Rayford McCloud  
107 4<sup>th</sup> St.  
Erwin, NC 28339  
Ph: 919-658-3699

Re: Engineering Services  
2665 Ash Ave.  
Dunn, NC

Tyndall Project No.: 1701-020196

**FIRST FLOOR PLAN**  
 1/8" = 1'-0"      CEILING HT. = 7'-4"

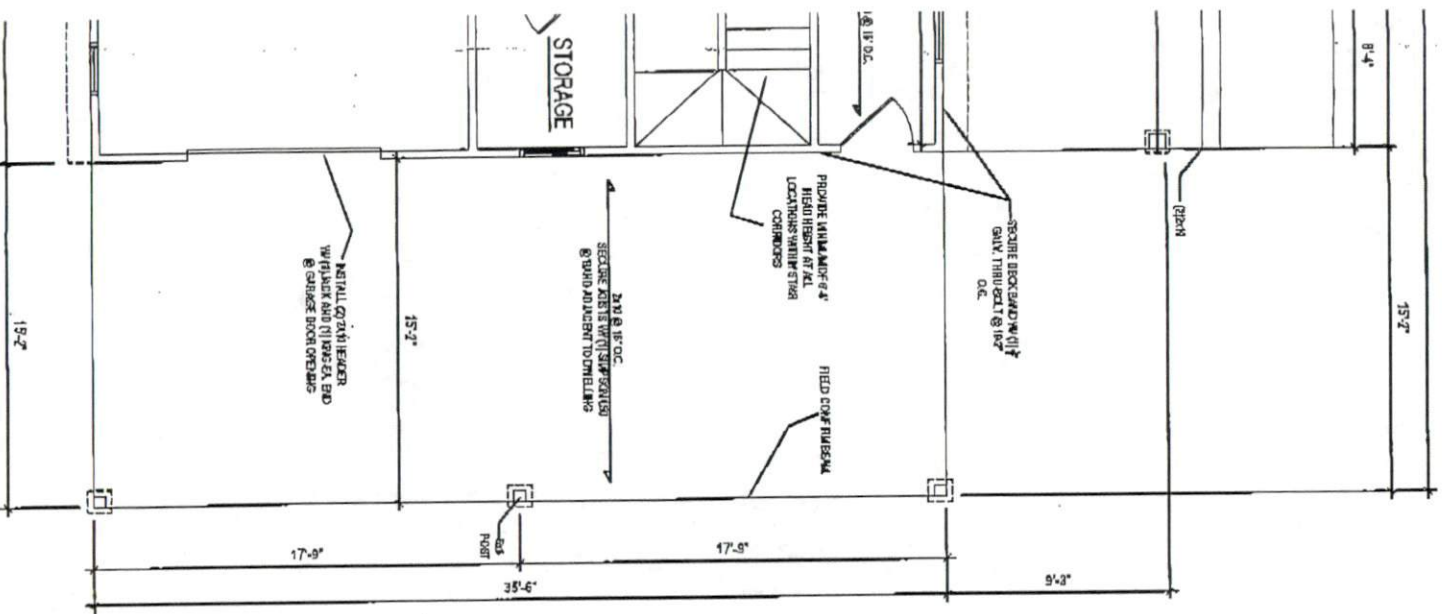
- 1) Floor joists associated with the ground floor were noted as being approximately 8" above the existing crawlspace grade. The existing floor joists were noted as being untreated 2x8 SYP joists placed at 16" O.C.
- 2) Untreated wooden girder members placed in direct contact with masonry associated with the girder support.
- 3) No means of foundation ventilation provided for crawlspace.
- 4) Minimum head height requirements (6'-8") not met at steps leading from 1<sup>st</sup> floor To 2<sup>nd</sup> floor.
- 5) Minimum head height requirements not met at 2<sup>nd</sup> landing encountered during ascension to 2<sup>nd</sup> floor.
- 6) Header not installed at single car garage door opening.
- 7) 1<sup>st</sup> floor wall studs 2x4 @ 16" O.C. in-lieu of code 2x6 for 3-story residential structure.

- 8) 4ft. Cantilever (2x10 floor joists) @ 3<sup>rd</sup> floor balcony.
- 9) Can't confirm roof support beam at covered porch roof located on right side of dwelling.

- 1) The joists' proximity to the finished grade does not meet the intent of the NC Residential Building code. TE&D recommends that this condition be addressed with the implementation of one (1) of the following options:

- a) Remove the existing subfloor to allow access to the floor joist. Apply a wood sealant/preservative product (such as Woodlife Coppercoat Wood Preservative) in accordance with all manufacturer recommendations.

- b) Remove the existing untreated floor joists and replace them with treated members.
- 2) Provide metal flashing between the bottom of the floor joists and the top of the masonry units so that no direct masonry/wood contact remains.

- 3) The foundation should be provided with a means of foundation ventilation. Non-typical vents (such as soffit vents) may be installed through the masonry foundation block. Based on our observations and analysis, approximately 64 sq. in. of ventilation is required. The recommended foundation vents should be installed on at least two (2) sides of the existing foundation.

- 4) This condition occurs at multiple points within the stair corridors. TE&D recommends rebuilding the staircases as necessary to provide minimum head height clearances (6'-8"). Note: Installing a spiral staircase may be an option that could be considered for this item.

- 5) Based on our observations and analysis, TE&D recommends that a (2) 2x10 (spf) header be installed at the location in question. Provide one (1) Jack stud and one (1) king stud at each end.

- 7) Based on our observations and analysis, 2x4 wall studs (approx. 7' height) are adequate to support the anticipated loading conditions. No action required.

- 8) TE&D recommends that the backspan and supporting framing be field confirmed so that the joists may be properly analyzed.

- 9) TE&D recommends that the beam be field confirmed so that it may be properly analyzed. Our load estimates indicate that the beam should be on the order of a 3-1/2"x14" Parallam to adequately support the anticipated loading conditions.
